**Agenda**  
**City of Springboro Planning Commission Meeting**  
**Wednesday, March 19, 2025, 6:00 p.m.**  
**Council Chambers, City Building, 320 West Central Avenue**

**Background Information & Staff Recommendations**  
**City of Springboro Planning Commission Meeting**  
**Wednesday, March 19, 2025, 6:00 p.m.**  
**Council Chambers, City Building, 320 West Central Avenue**

**A. Final Approval**  
**Record Plan, Eastbrook Farm, Section One**

### **Final Development Plan, Easton Farm PUD-MU, Planned Unit Development-Mixed Use, 605 North Main Street, multifamily component**

# EASTBROOK FARMS SECTION 1

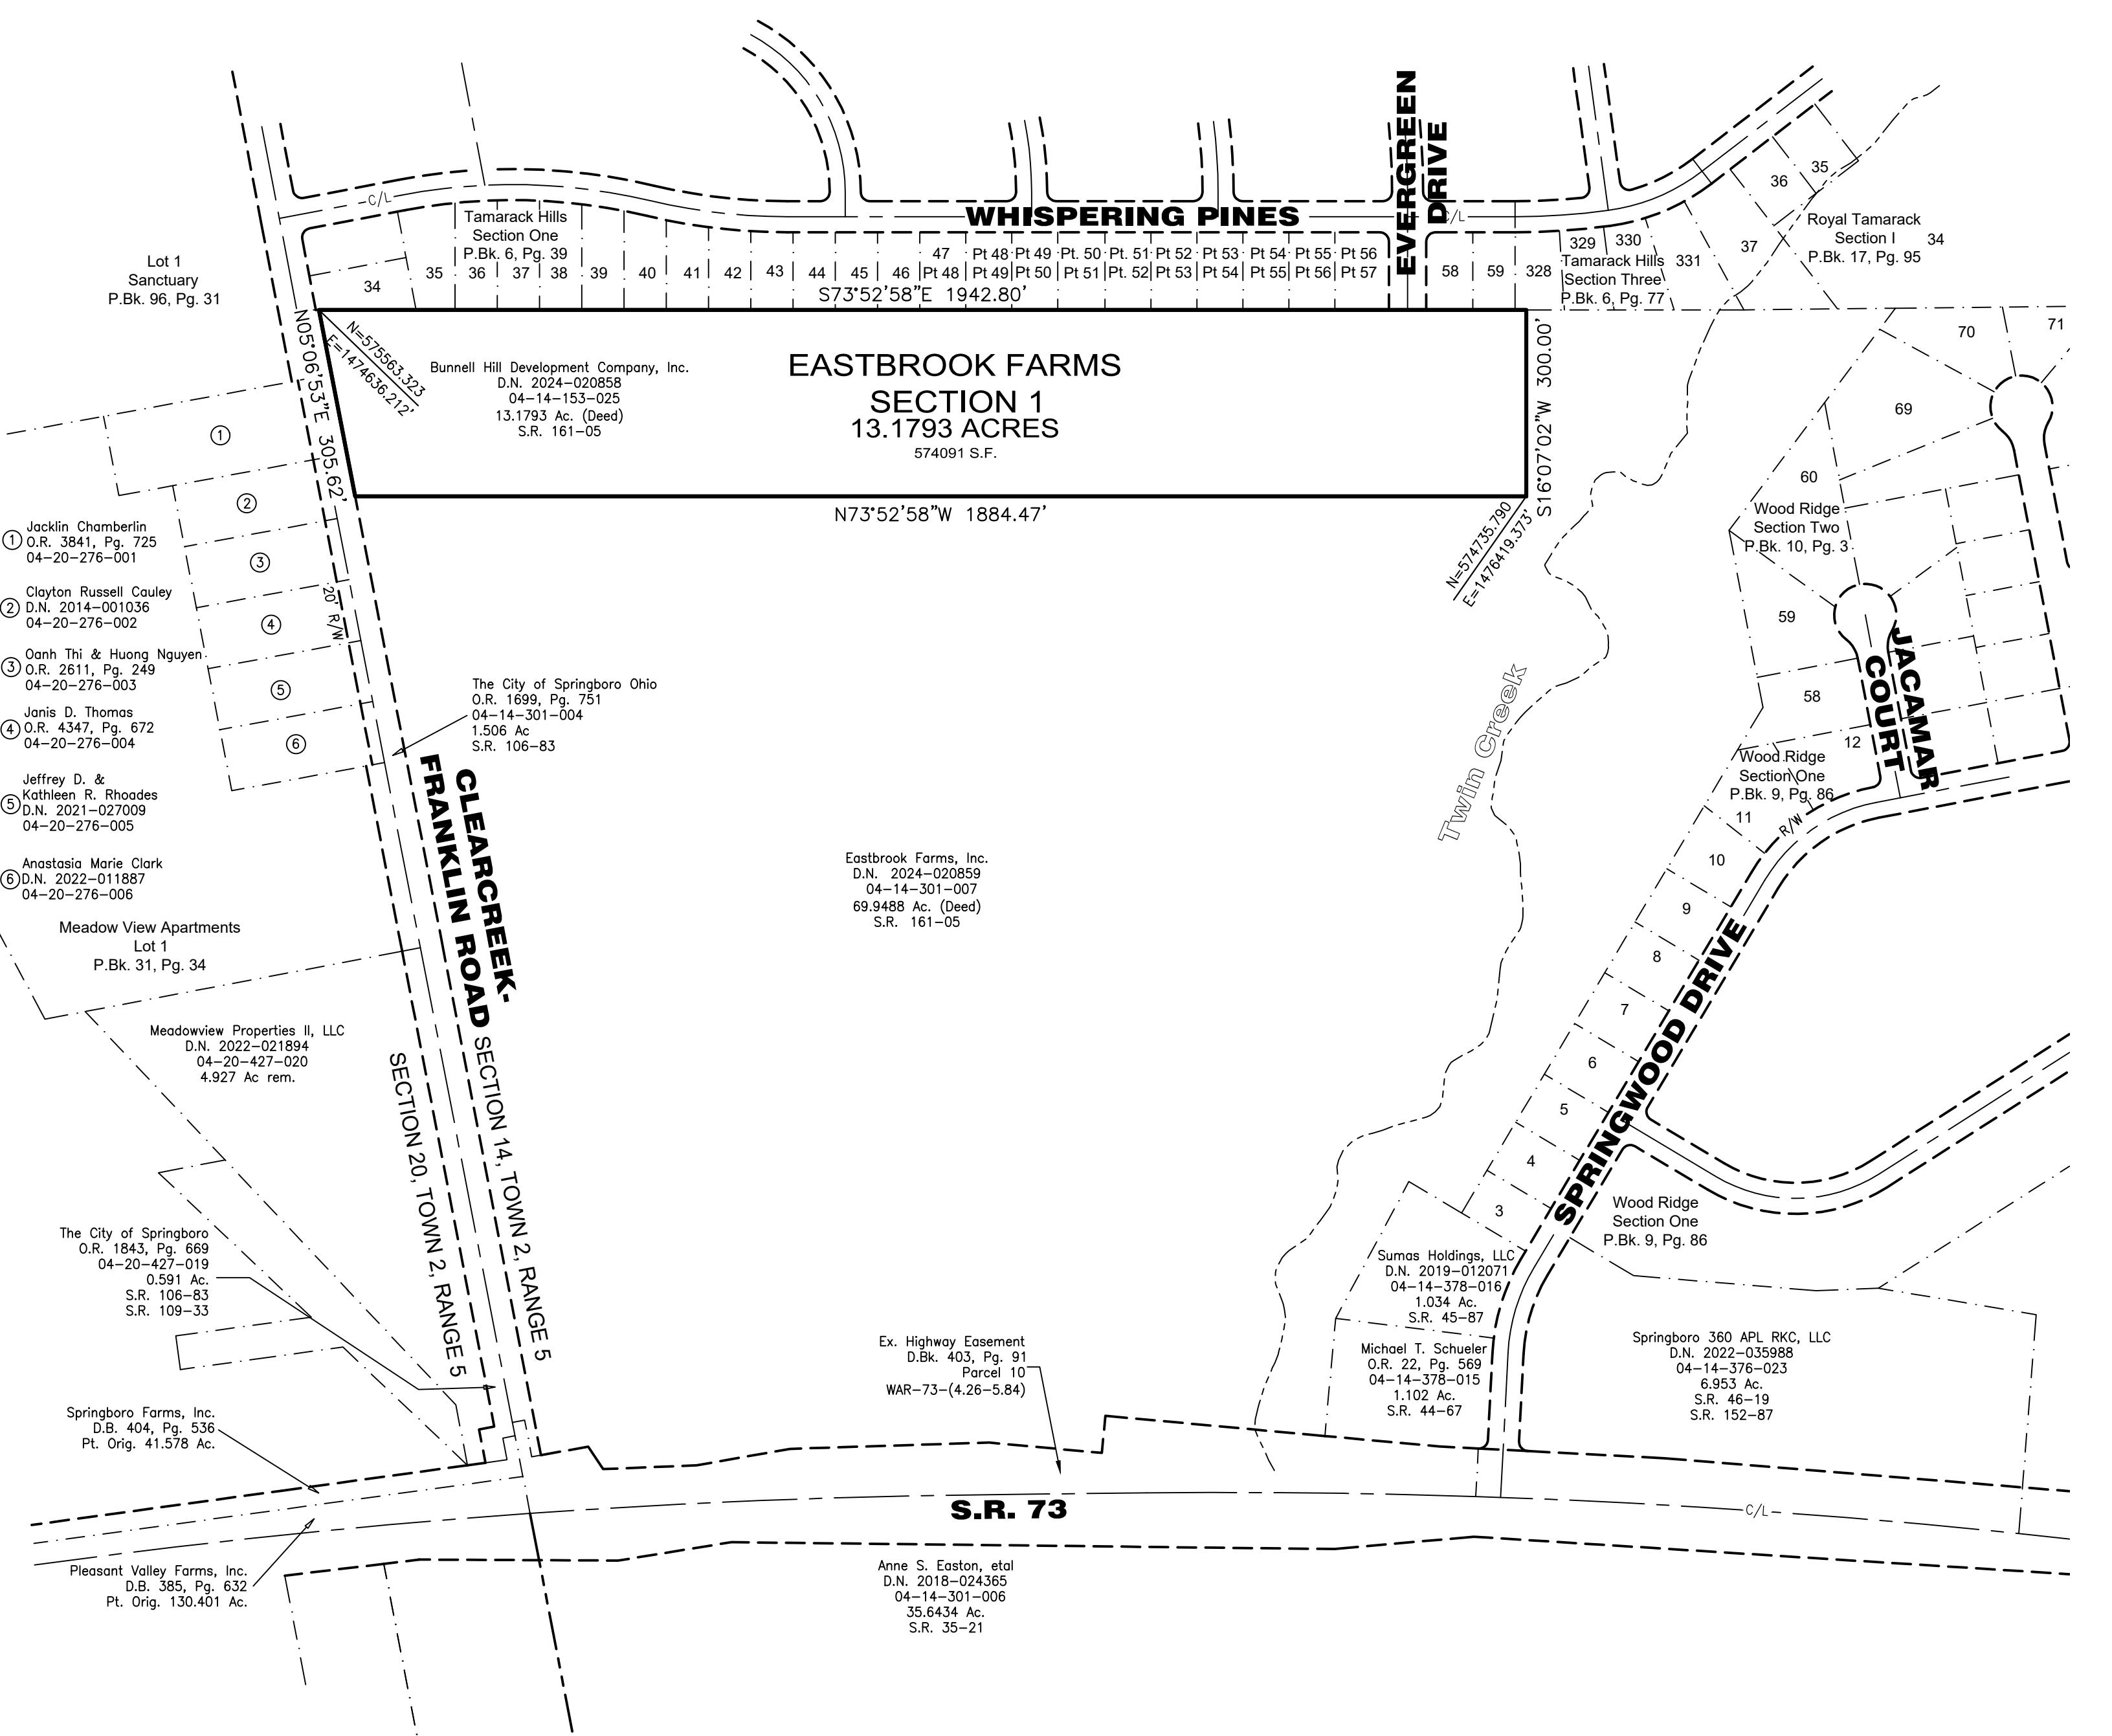
1. Add "Record Plan" to the title block.
2. Provide HOA documents for review and approval. Add the HOA recording information in General Notes.
3. Provide off-site easement recorded documents prior to city council approval. The HOA will be responsible for maintaining the offsite easement areas, except for the public sanitary sewer; add wording to easement documents accordingly.

4. Add Note 8: "All lots shall be subject to a publicly available drainage easement five (5) feet in width along all side yards and ten (10) feet in width along rear lot lines, except as otherwise noted."

5. Fill in HOA recording information on notes 5 and 6.
6. Add the following statement in the owner consent and dedication signature block statement regarding any offsite easements "We further grant to the City of Springboro the right to all utility easements as shown herein on the un-platted property until such time as they are formally dedicated in a future Record Plan or recorded by easement document." This can go right before the sentence "The above utility easements are for the benefit of all public utility providers....."

7. Submit to Warren County for review and revise accordingly.

Sheet: C4.0

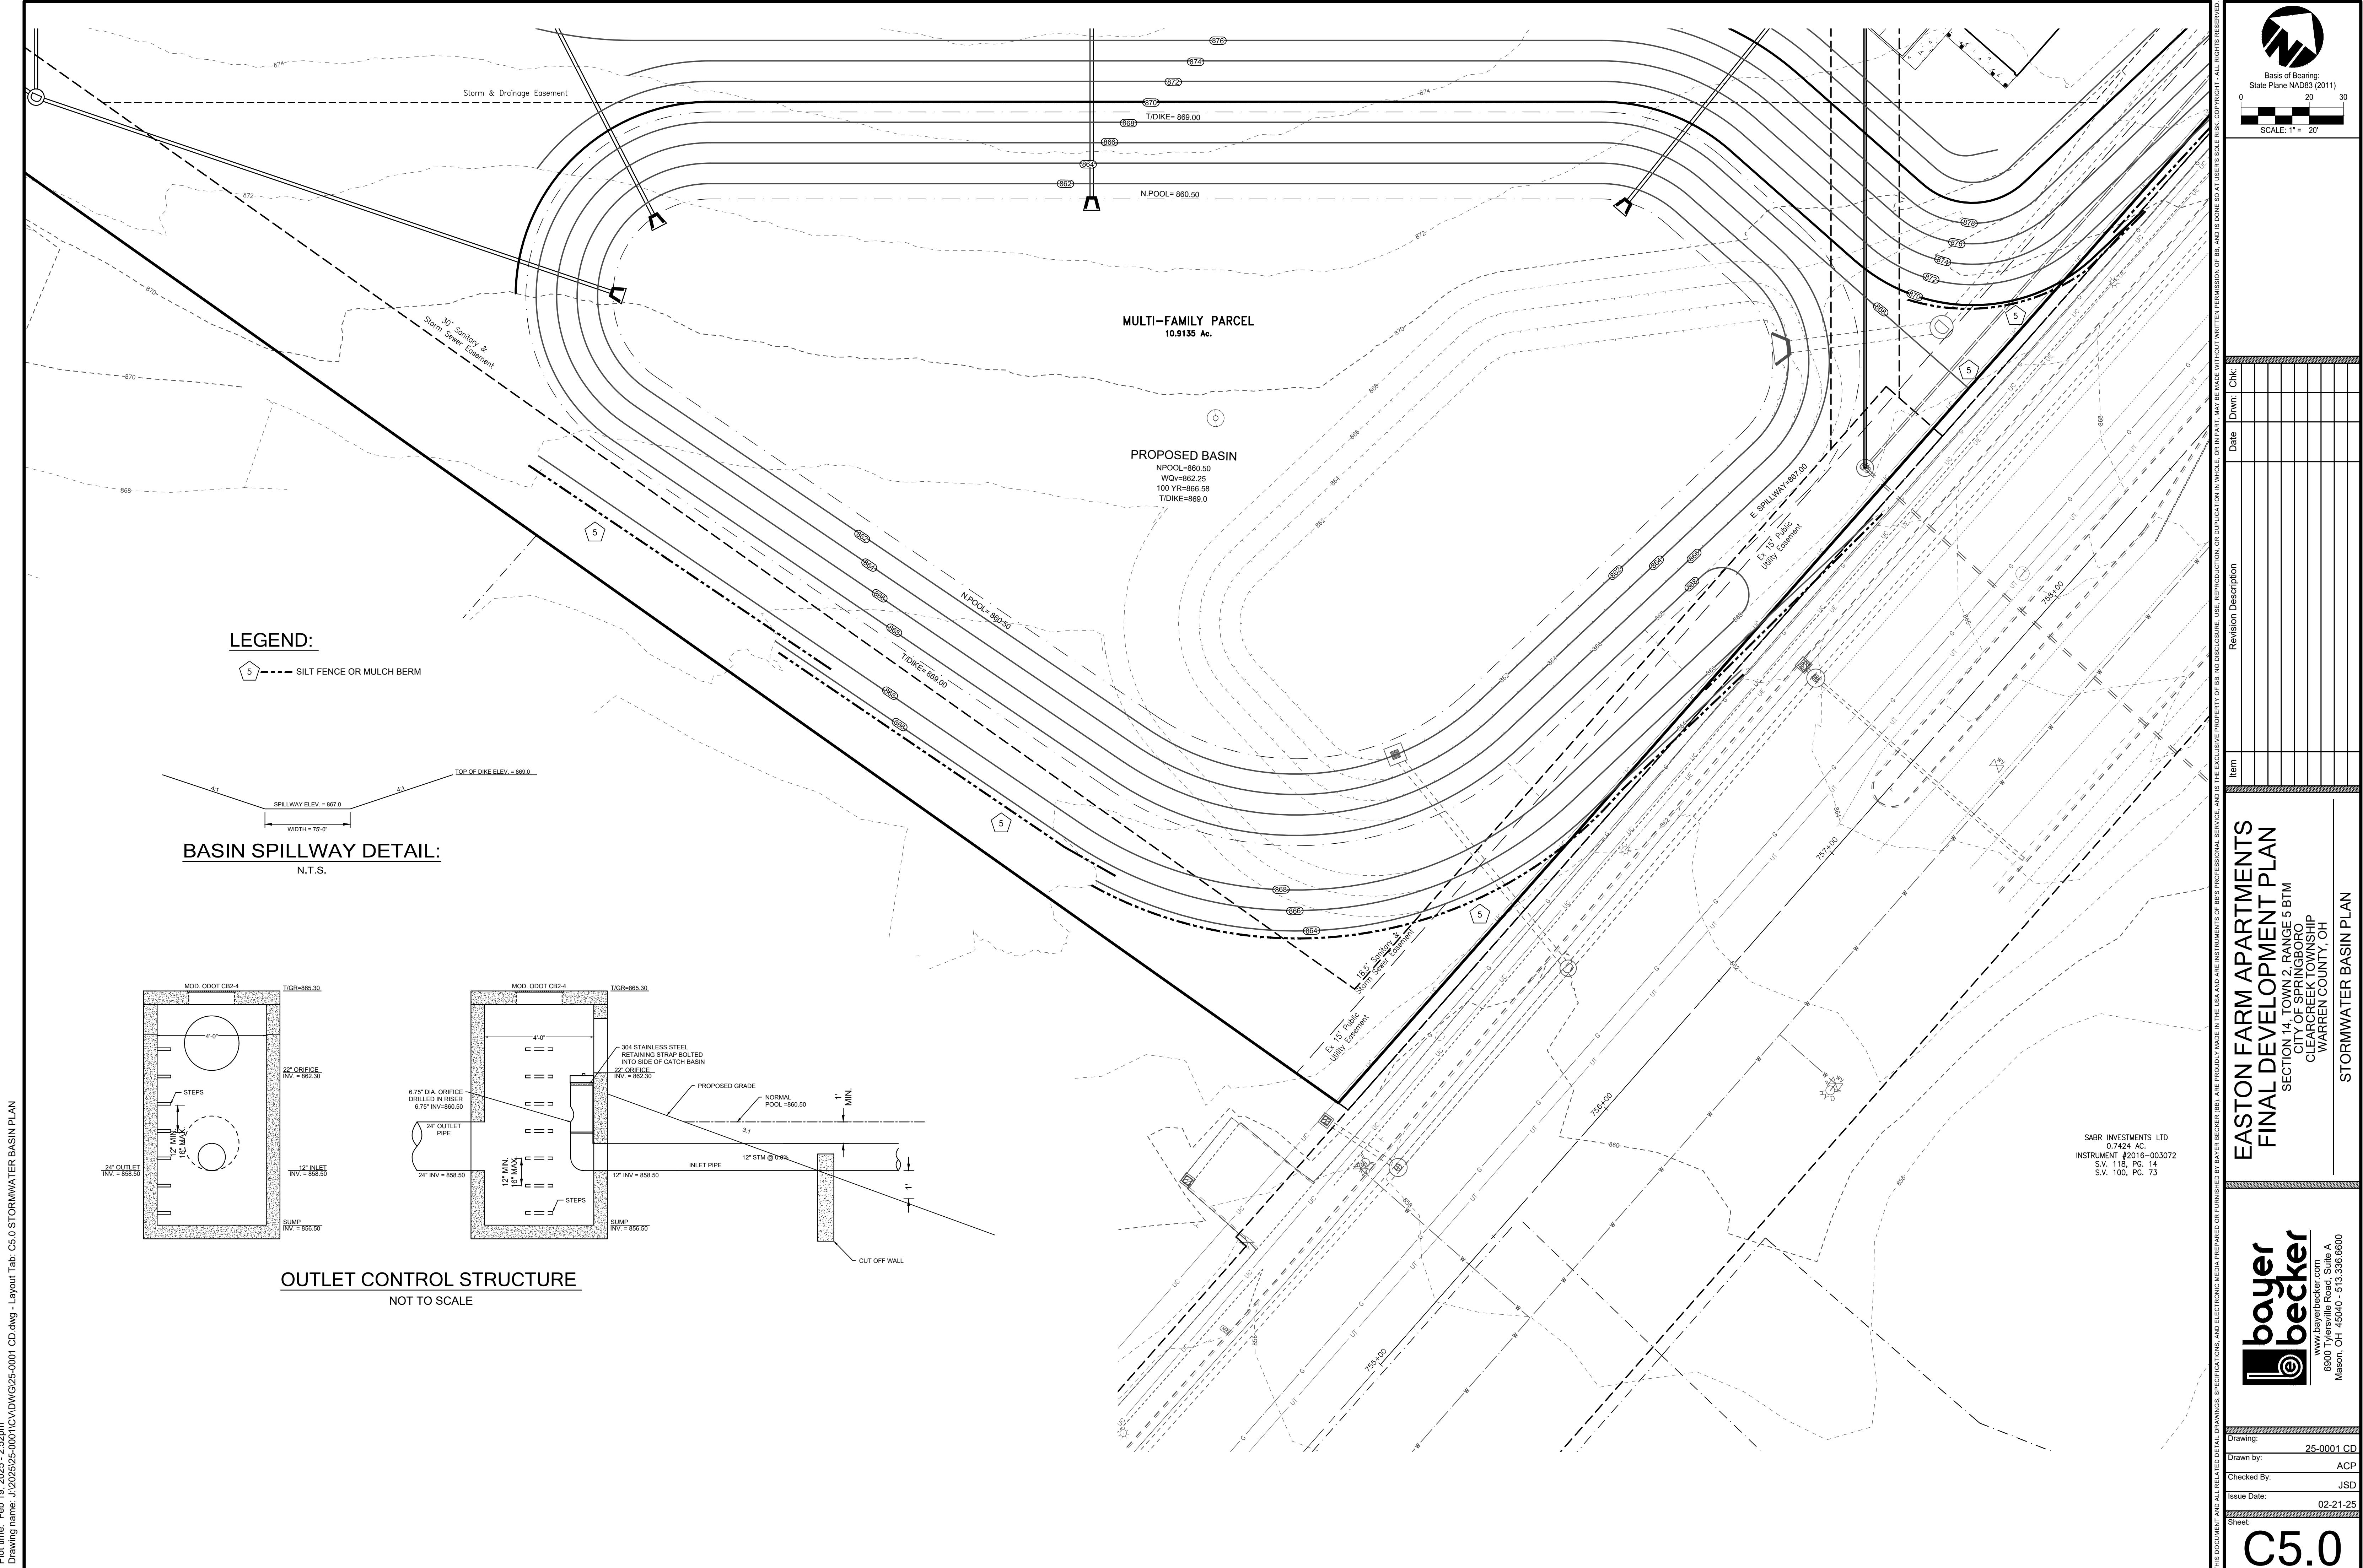
15. Provide site plan design details including, but not limited to, storm sewer, sanitary sewer, water main, private roadway details, and grading.
16. Provide water master meter in each building in a meter room.
